Three Mile Island Nuclear Station
Special Operating Procedure

SIDE 1
SOP No. 2-37 (REV)
(From SOP Log Index)

1. Title Alternate Pressurizer Level Indication

2. Purpose (include purpose of SOP)
To provide alternate source of pressurizer level indication in the event RLI-LTI, 2 & 3 all fail

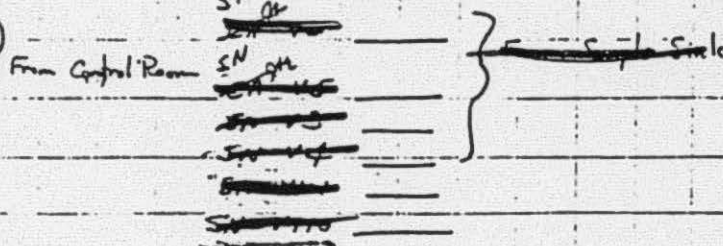
CA-V6
SN-V101

~~SN-V101~~

• Partial Figure 2 Ref. Dwg 2031

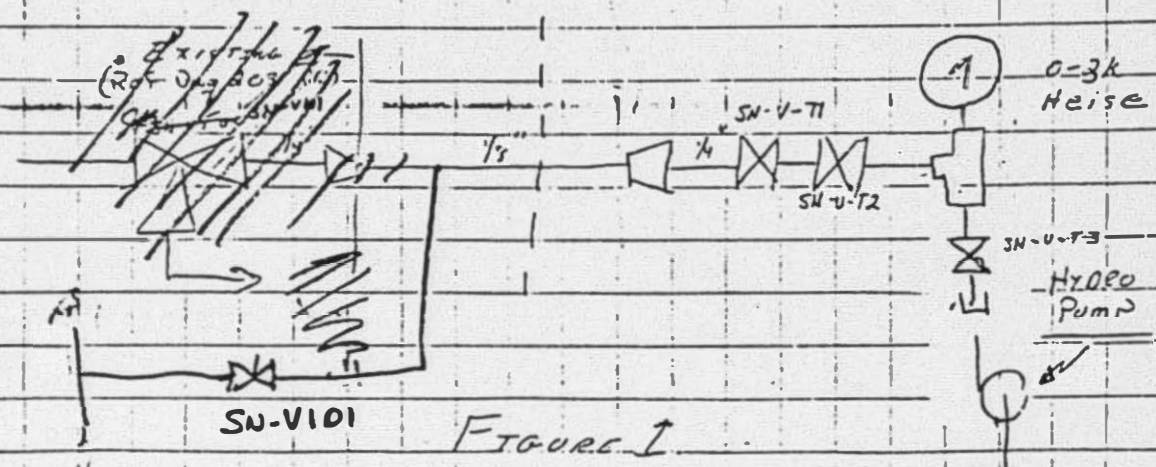
2. Install ~~1/4" x 1/4"~~ 1/4" x 1/8" reducing on 1/4" tubing downstream of ~~SA-V5~~ SN-V101 (Refer Fig 1)

4. Install 1/8" - 1/4" reducer, isolation valves, pipe tee with 0-3000 psig Heise Gauge and cap as shown in Figure 1.

See NOTE: Fill newly installed tubing with water and vent water thru Heise Gauge prior to connecting tubing to ~~SA-V5~~ SN-V101 to remove air from tubing.

6. Pressurize tubing back to ~~SA-V5~~ SN-V101 to 2500 psig and check for leaks. Repair leaks as needed, then vent pressure when complete.

Figure 2

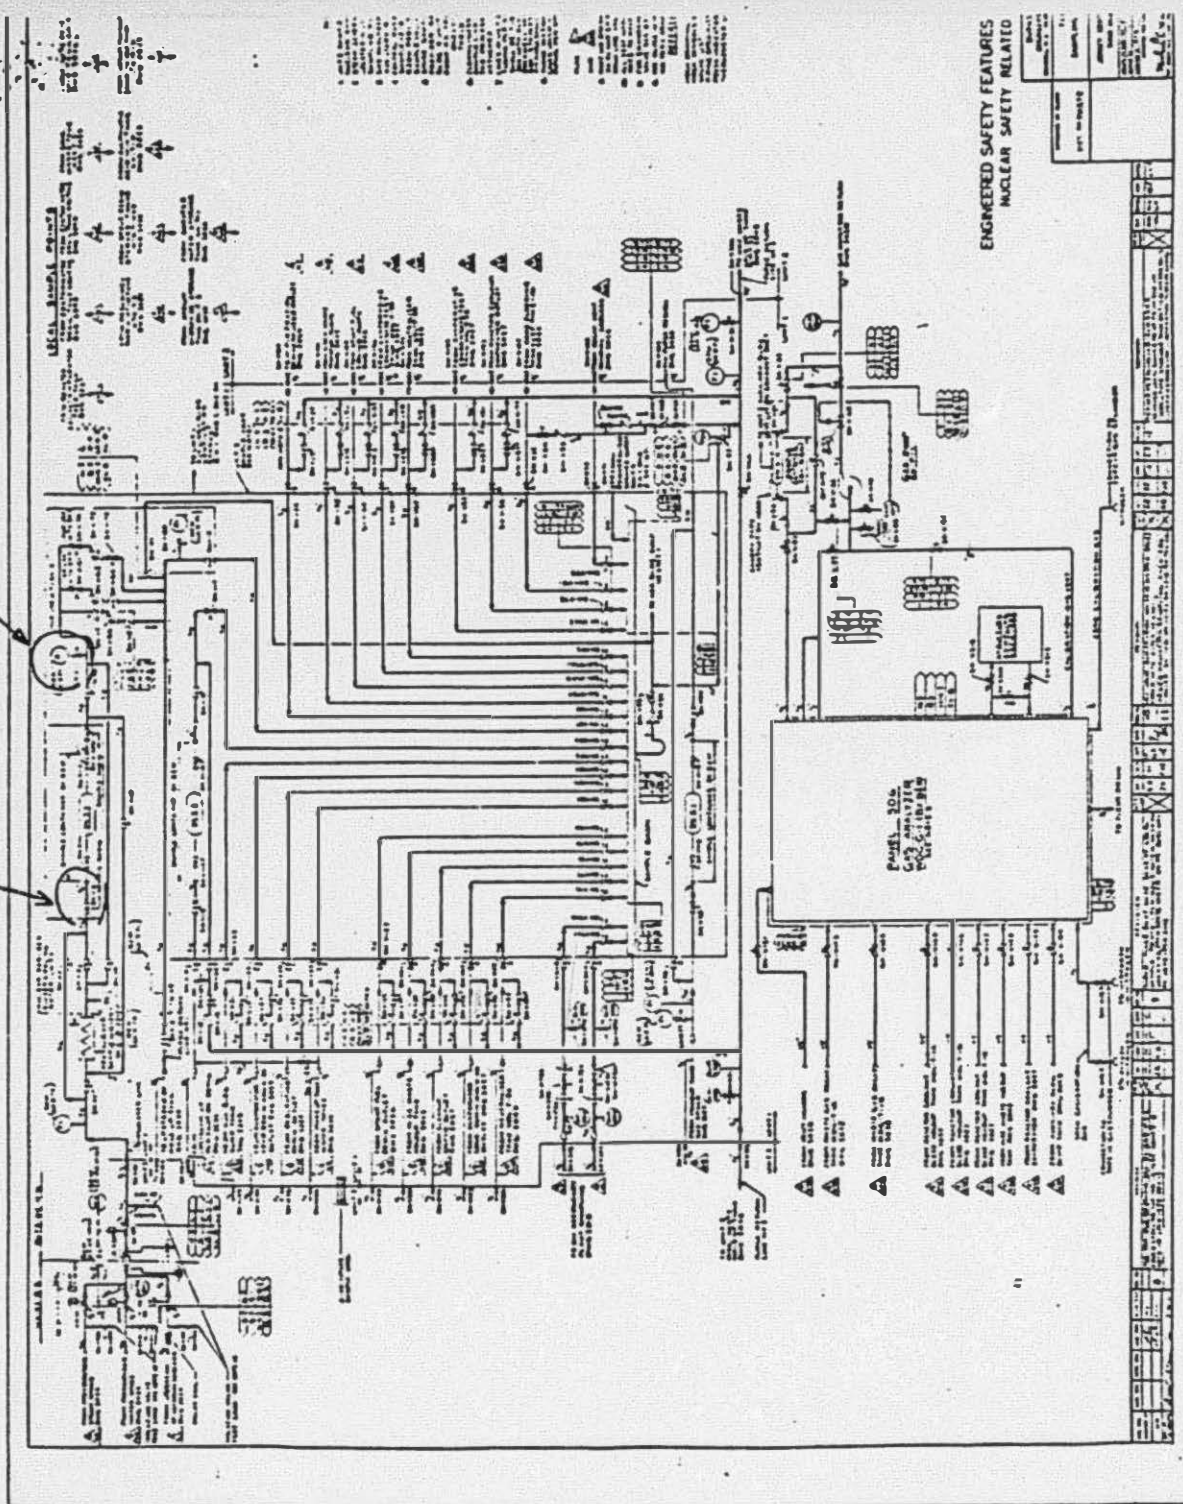
V-05
SN-Viol
